GLAMORGAN/SPRING BAY COUNCIL
NOTICE OF PROPOSED DEVELOPMENT

PROPOSAL: **(Re-Advertised) Subdivision of One (1) Lot,**
Change of Use from Class 10a to Class 1a, & New Dwelling (Staged)

PROJECT: 1 OYSTER PLACE, ORFORD
SUBJECT: SUBDIVISION, CHANGE OF USE AND NEW DWELLING AT 1 OYSTER PLACE, ORFORD.

Please find responses to the GSBC RFI queries below using the GSBC RFI document as a basis for clarity and consistency.

Drawing	Lot 02 - Driveway and Crossover
	Other

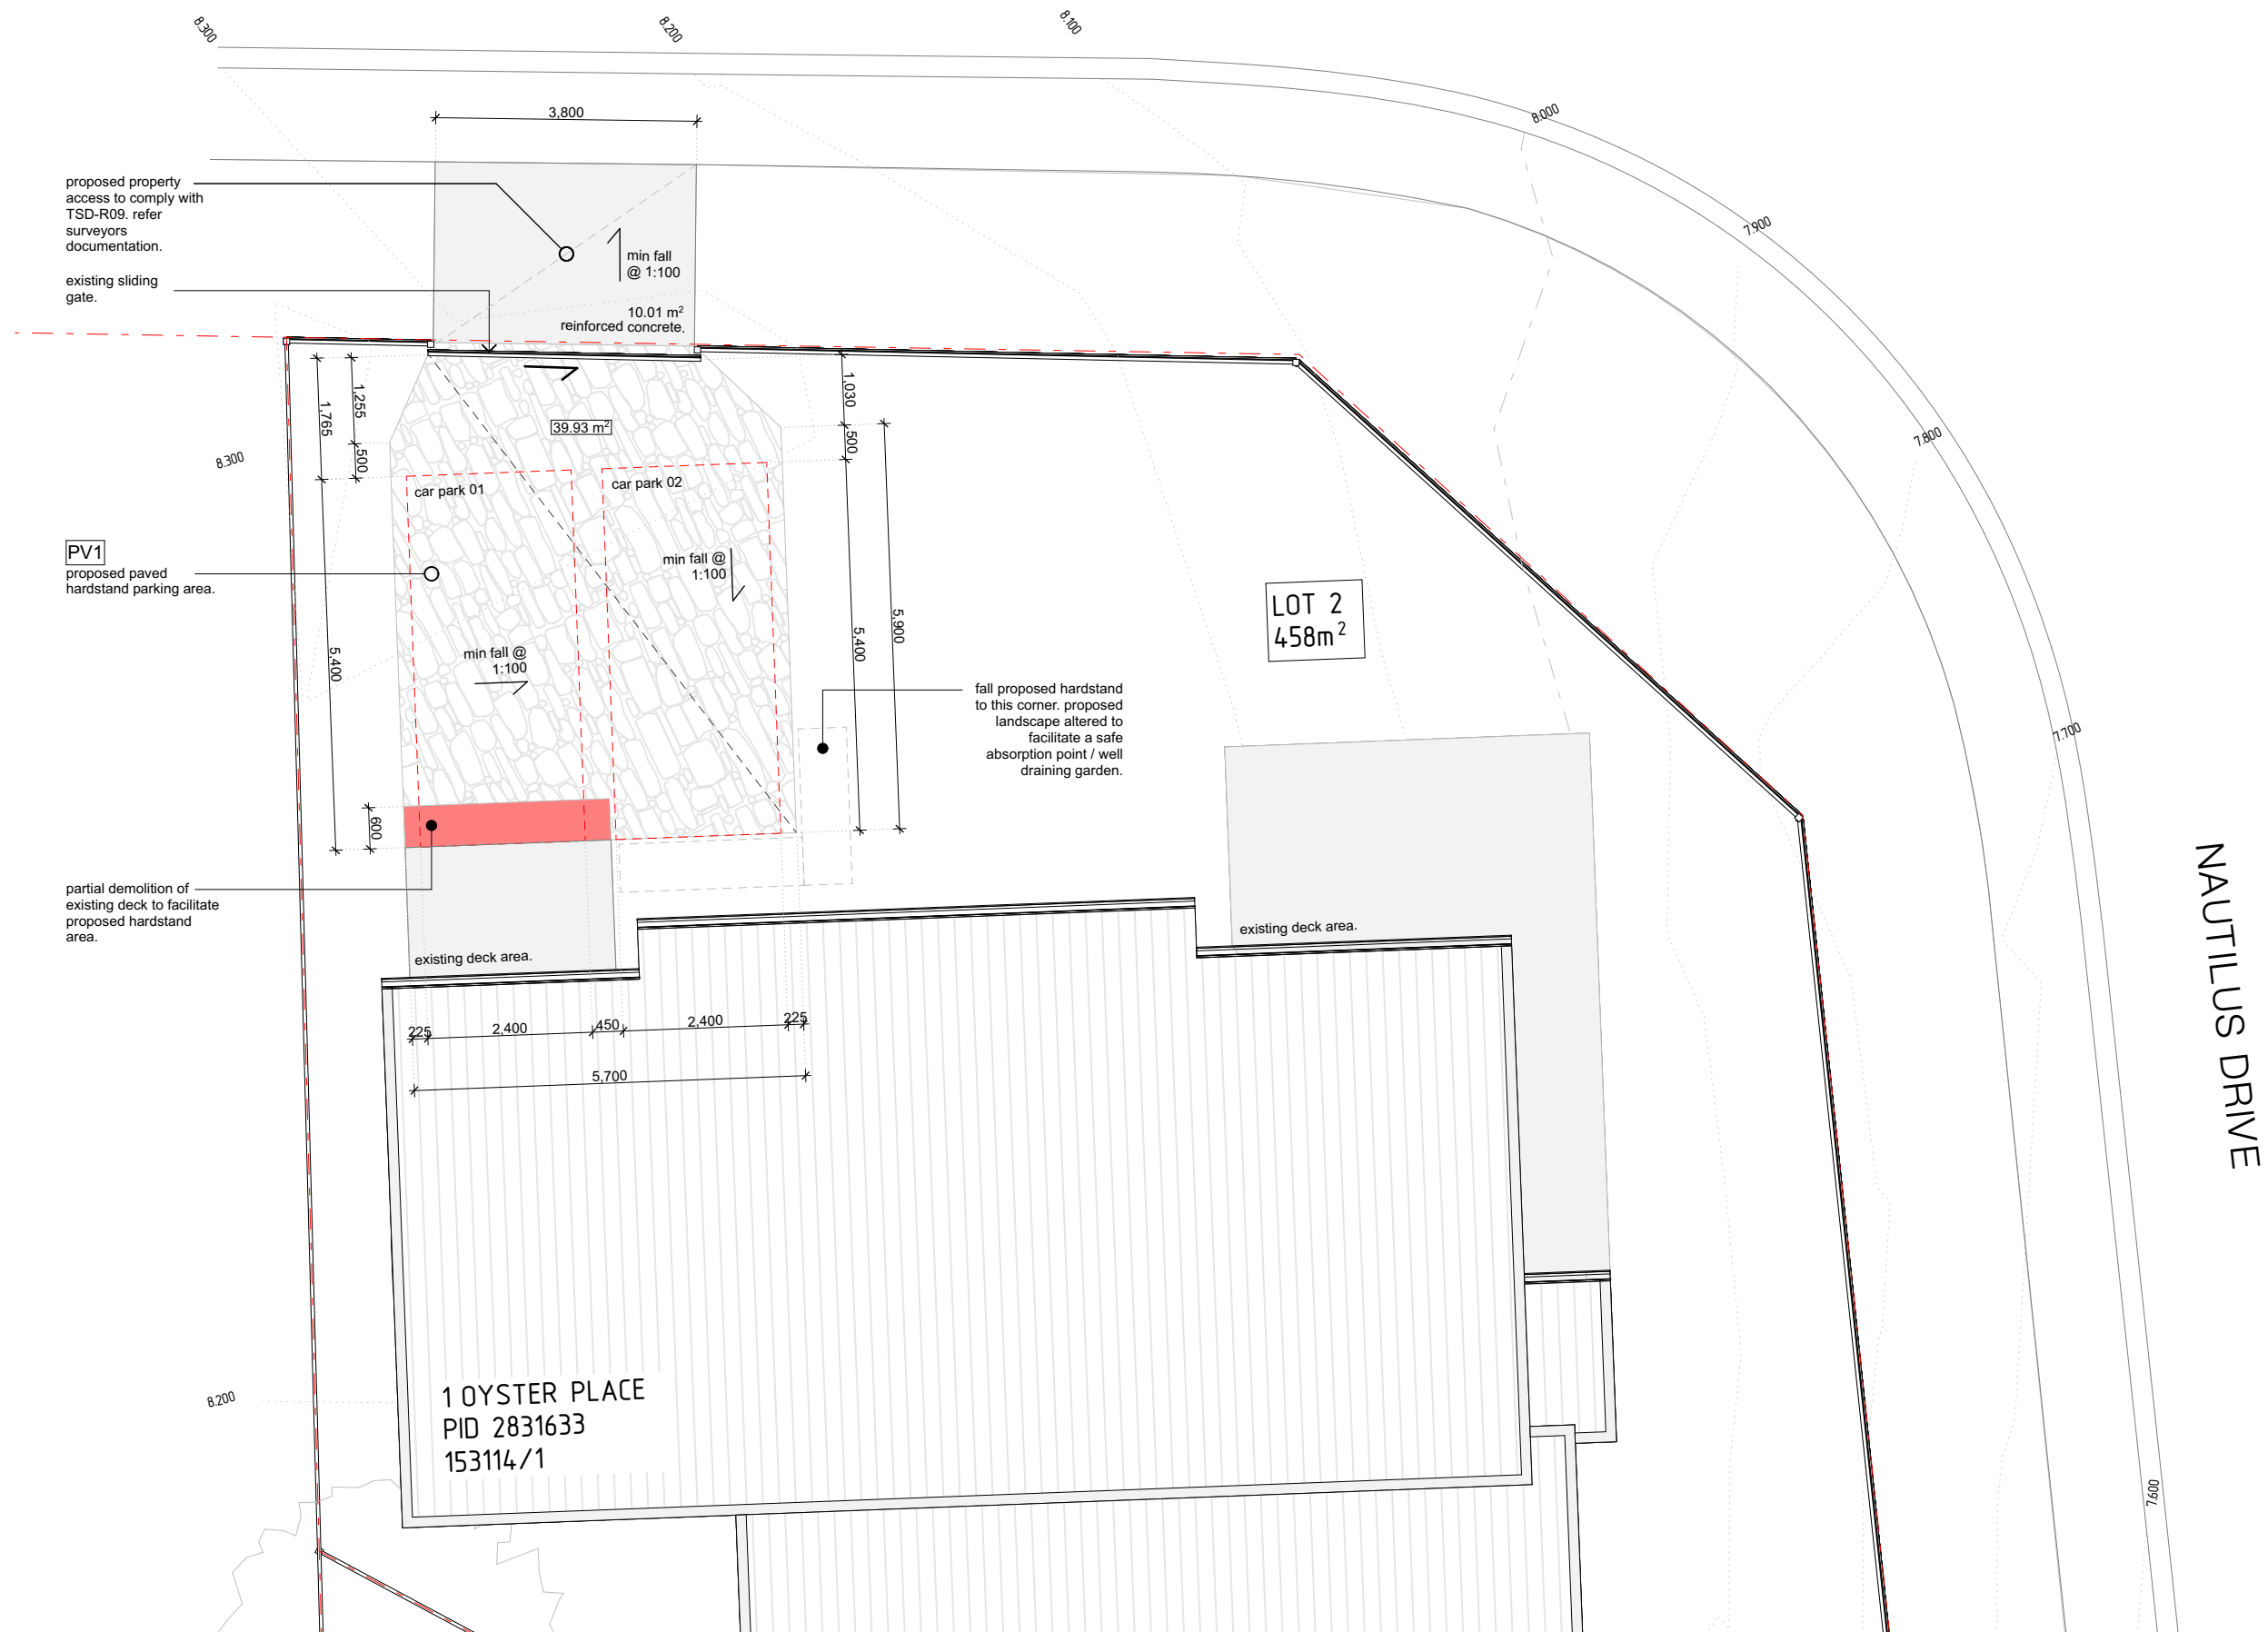
- Please submit amended plans showing that the driveways for both lots will use a durable all-weather surface such as spray seal, asphalt, concrete, pavers, or an equivalent material. The plans must also show that driveways will be drained to the public stormwater system or designed to contain stormwater on site, in accordance with Clause C2.6.1 A1(a), (b), and (c). Additionally, provide a minor stormwater management calculation to demonstrate that stormwater from the proposed development can be managed appropriately.

- The submitted plans lack sufficient detail to demonstrate compliance with Clause C2.6.2 A1.1.

Although the plans state that property access will comply with TSD-R09, they do not clearly confirm that parking, access ways, manoeuvring, and circulation spaces will meet either Australian Standard AS 2890—Parking Facilities, Parts 1-6, or the requirements of Clause C2.6.2. Please provide the width, length, and general gradients of the driveway and parking areas. The dimensions of the parking areas must be specified to accommodate car parking spaces for both the lots. Where the proposal cannot meet the requirements of the Acceptable Solution, sufficient documentation should be submitted demonstrating compliance with the relevant Performance Criterion.

Response: *Both the driveways for Lot 1 and Lot 2 are proposed to be paved and have been designed to deal with stormwater on site. As advised by the Development Engineer from Glamorgan Spring Bay Council on the 6th of July, the extent of the impervious area has been shown on the updated documentation, together with the proposed drainage arrangement. This should generally be sufficient to satisfy the minor stormwater management requirement. Refer to the updated architectural documentation.*

Response: *Architectural plans have been updated to provide detail demonstrating that the proposed parking areas for both Lot 1 and Lot 2 are compliant with Clause C2.6.2 A1.1. Similar to the driveway access at 3 Oyster Place, the existing kerb (appears to be Type KCM on LGAT Drawing TSD-G04.V2) doesn't require altering to facilitate entry into the proposed driveway. See Google Street View image of 3 Oyster Place entry adjacent.*
